Technical Note

Project No: ITB13091
Project Title: Ford Airfield – The Landings
Title: Sustainable Accessibility Addendum Note
Ref: 13091-029
Date: 5 August 2020

TO:	Arun District Council FAO: Raymond Cole
FROM:	Stephen Gee WSCC - Highways Authority
DATE:	17 April 2020
LOCATION:	Land at Ford Airfield Ford, West Sussex
SUBJECT:	F/4/20/OUT Outline planning application (with all matters reserved except for access) for the development of up to 1,500 dwellings (Use Class C3), 60-bed care home (Use Class C2), up to 9,000 sqm of employment floorspace (Use Classes B1), local centre of up to 2,350 sqm including up to 900 sqm retail / commercial (Use Classes A1-A5) and 1,450 sqm community / leisure floorspace (Use Classes D1-D2), land for a two-form entry primary school (Use Class D1), public open space, allotments, new sports pitches and associated facilities, drainage, parking and associated access, infrastructure, landscape, ancillary and site preparation works, including demolition of existing buildings and part removal of existing runway hardstanding. This application affects a Public Right of Way. This application is the subject of an Environmental Statement. This application falls w

SCALE @ A3:	CHECKED:	APPROVED:
1:500	DS	DS
FILE REF:	DRAWN:	DATE:
ITB13091	SH	17.07.18
DRAWING No:		
ITB13091-GA-008		
PROJECT No:		REV:
ITB13091		A

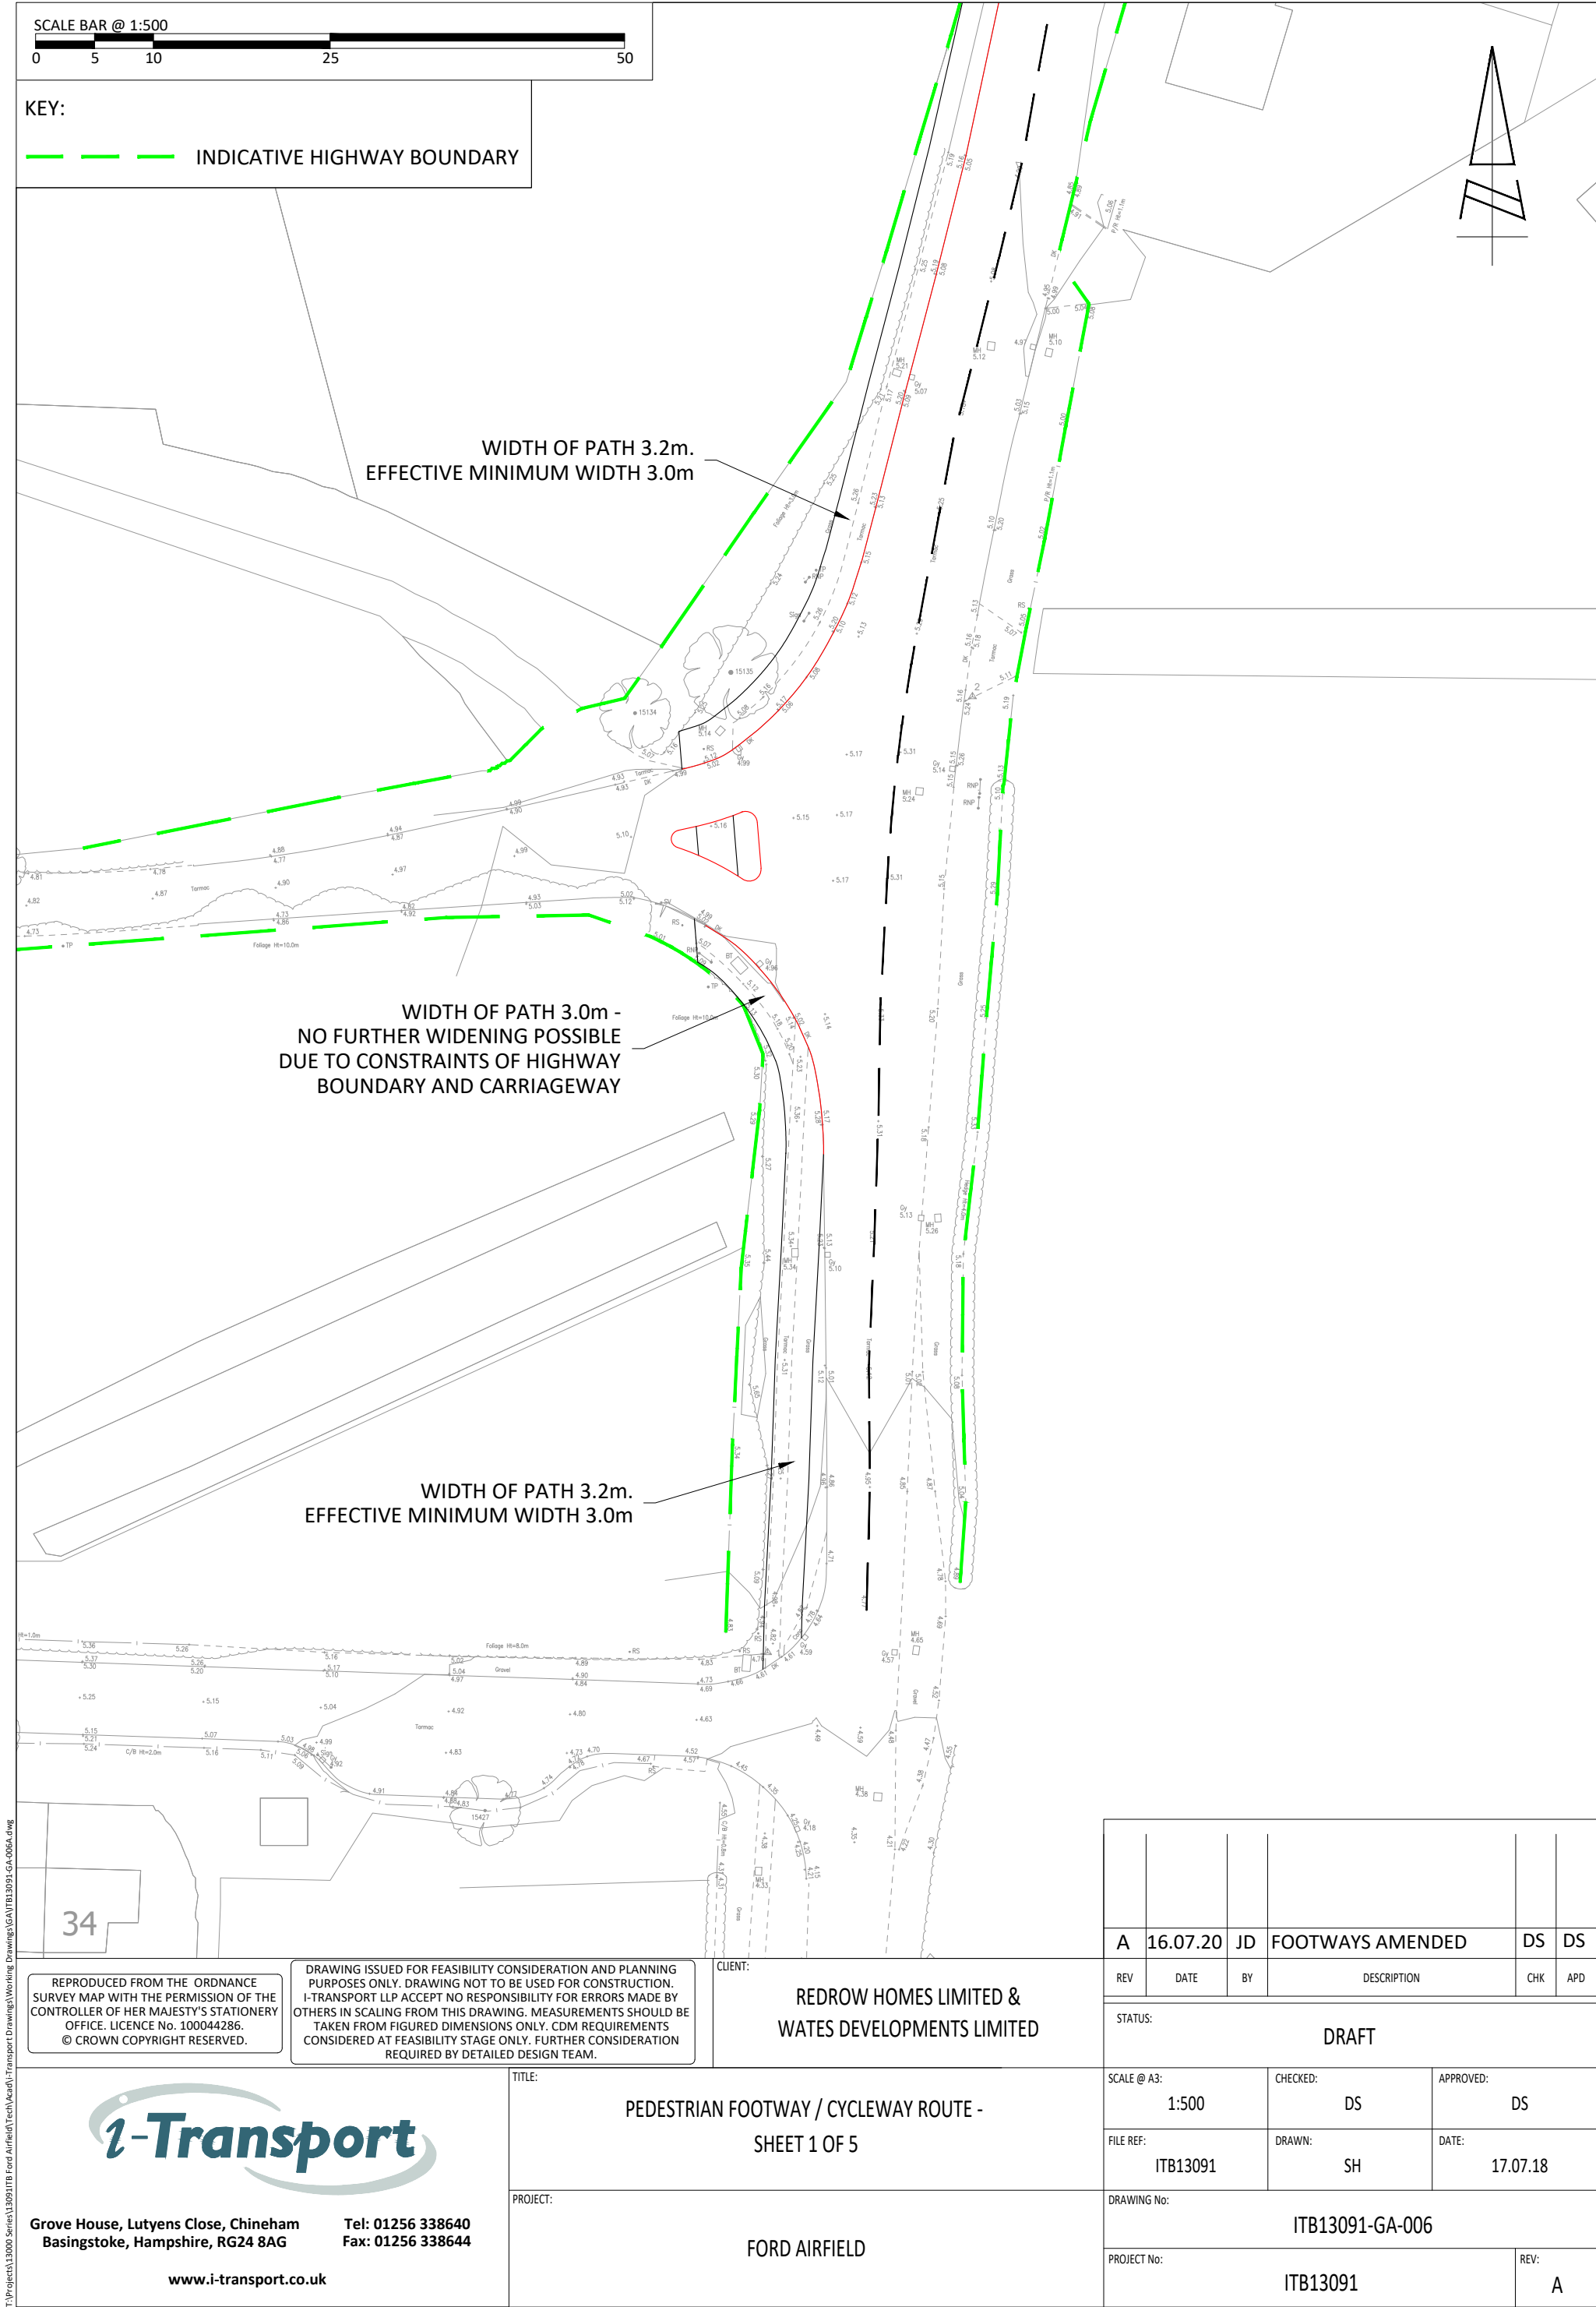
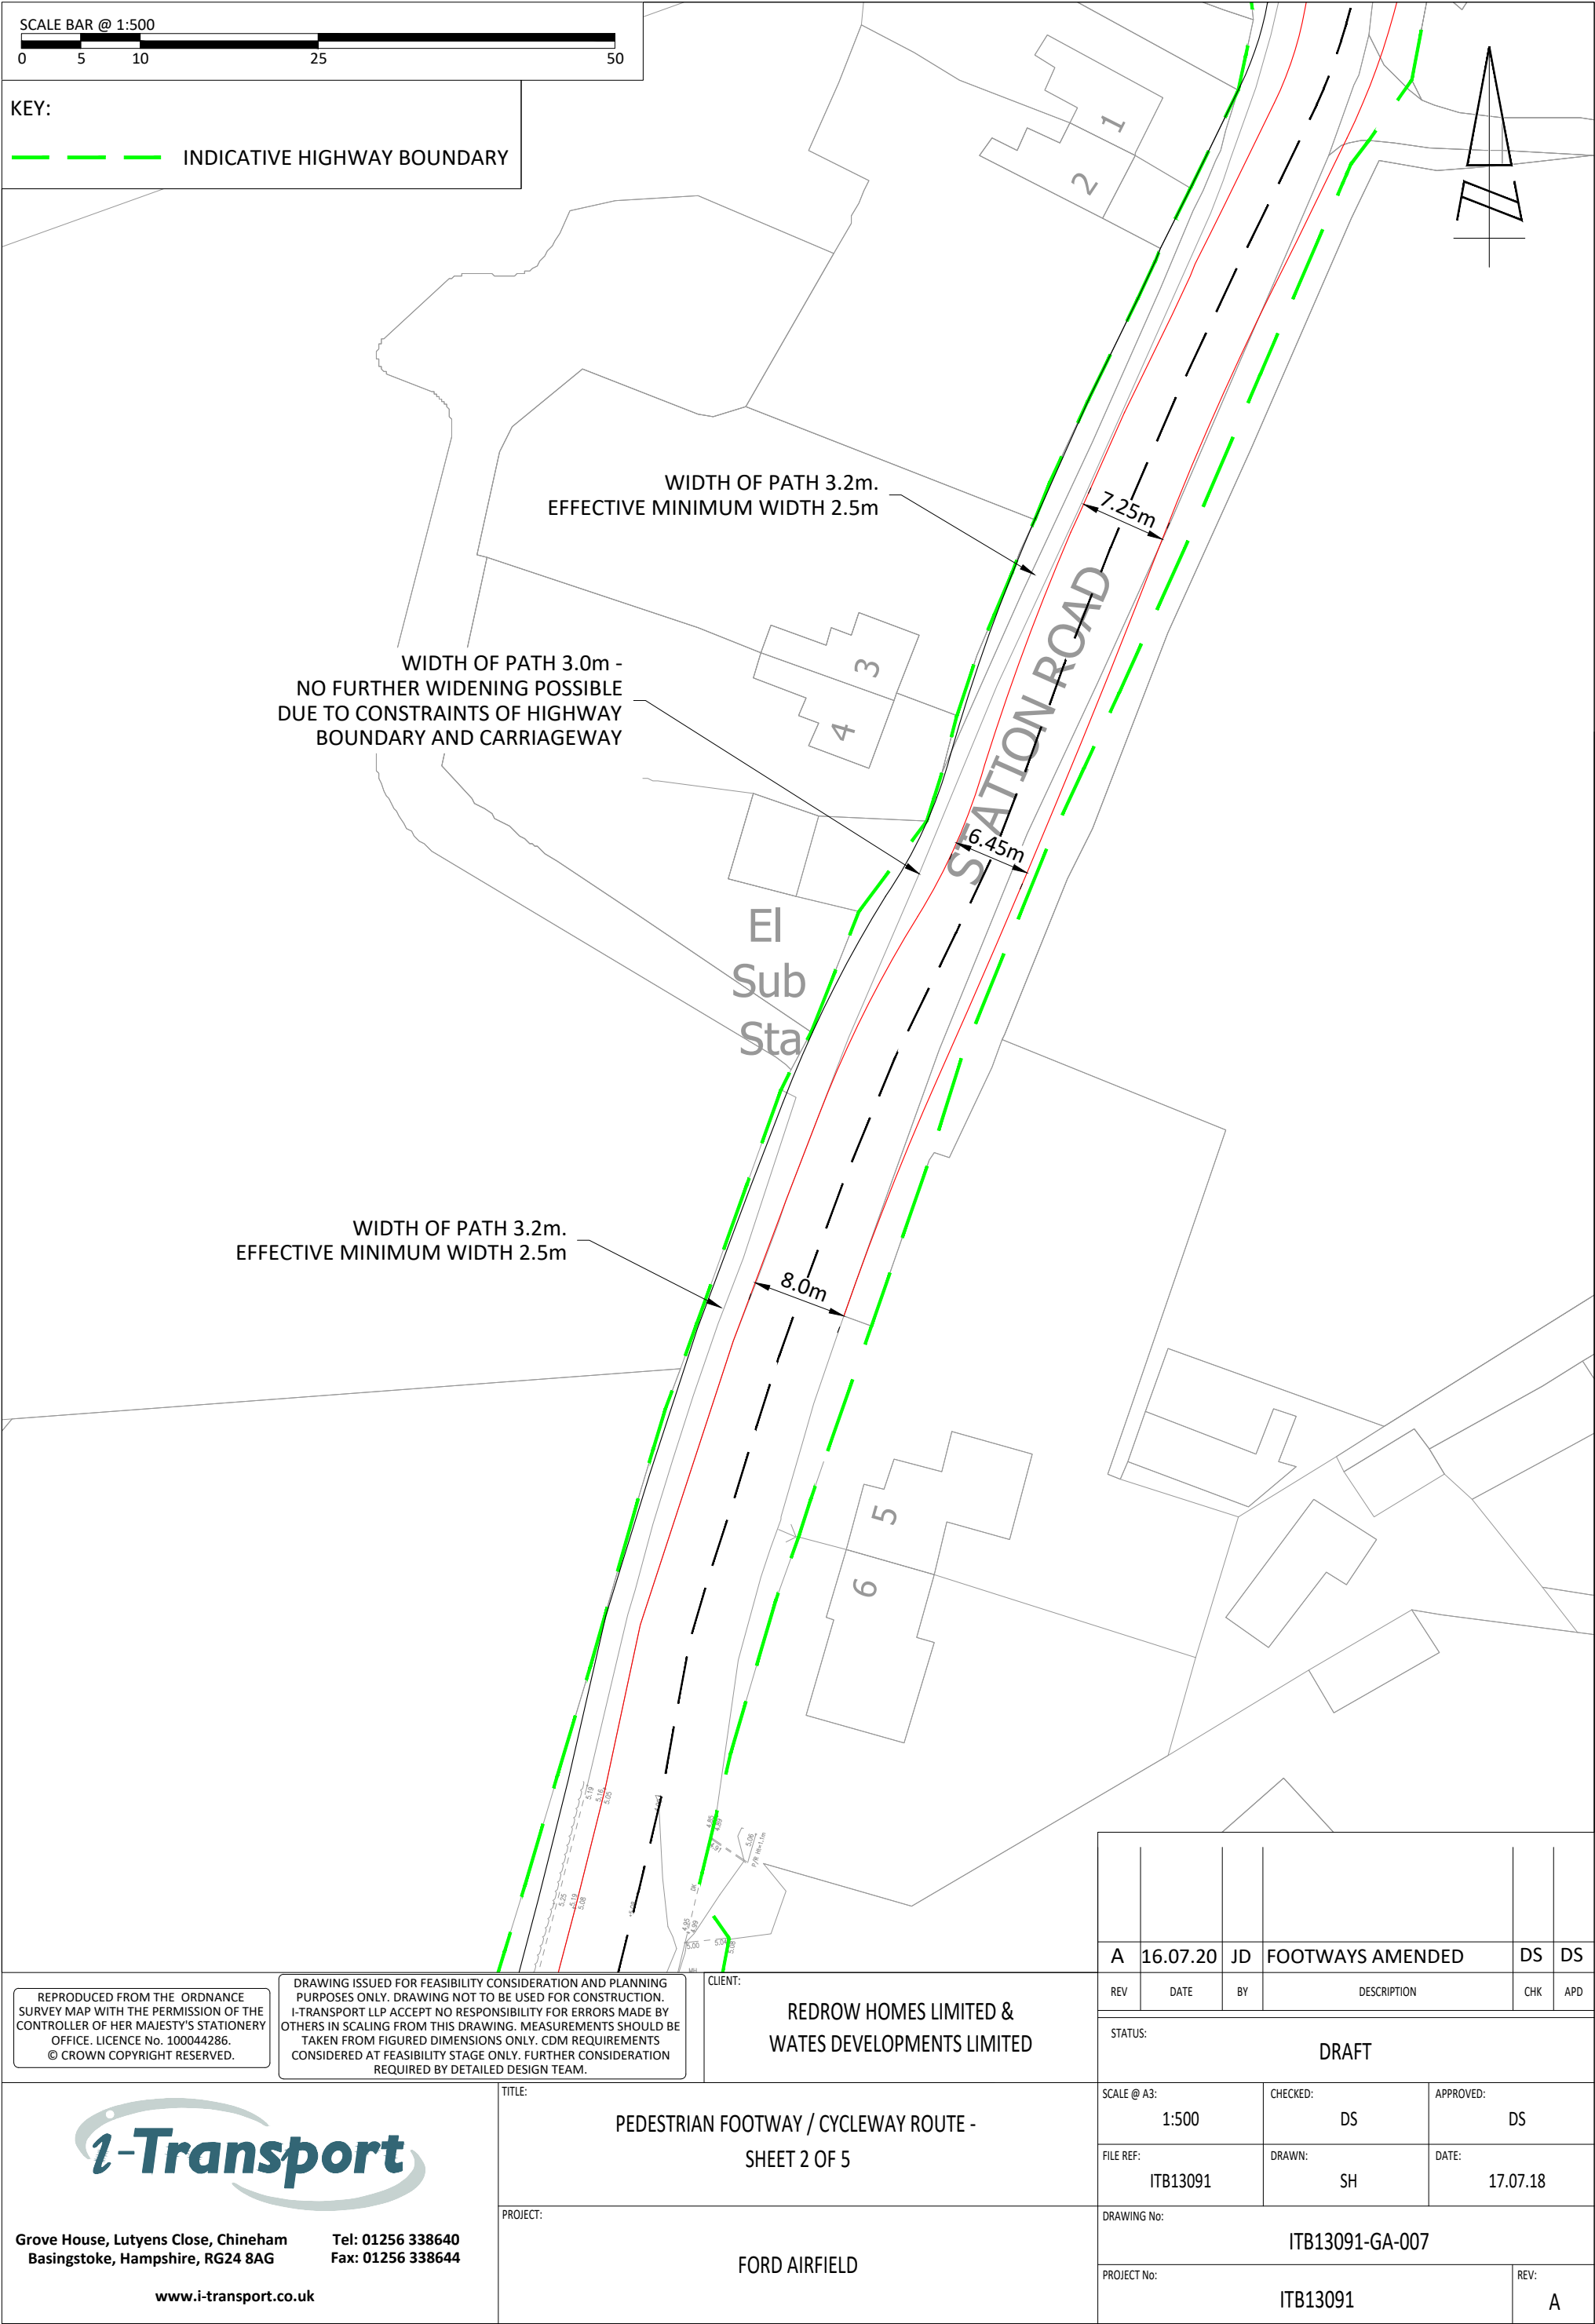
A 3m shared use route is proposed between the site and Ford Rail station. The connection to Ford Road is made through the use of Public Right of Way 200.3 which is accessed from within the development site. The 3m wide provision is then provide alongside Station Road, further clarification is required upon the ability to provide such width alongside property boundary treatments and features such as the bridge (over the stream) and the impacts on effective width.

- 3.6.3 Notwithstanding, the scheme of works identified within the original assessment has been reviewed in the context of the CDG. Given the need to retrofit an improvement scheme within the constraints of the existing highway, it is not possible to provide a route that is fully compliant with the guidance. As identified in the guidance, where it is not possible to do this then the provision should be considered on a site-specific basis.

- 3.6.4 The identified scheme of improvements has been reviewed to allow for additional widening where possible. At locations where the route does not have a vertical obstruction on the eastern side of the highway boundary, an effective minimum width of 3.0m has been achieved by providing for an additional 200mm widening, achieved by offsetting the carriageway to the east of its existing alignment, or narrowing the carriage marginally (while maintaining a road width of a minimum of 6.8m). Where a vertical obstruction is present (e.g. a boundary wall or vegetation) the effective width reduces to 2.5m.

- 3.6.5 The revised scheme of improvements is presented in Drawings **ITB13091-GA-006 Rev A – ITB13091-GA-010 Rev A**.
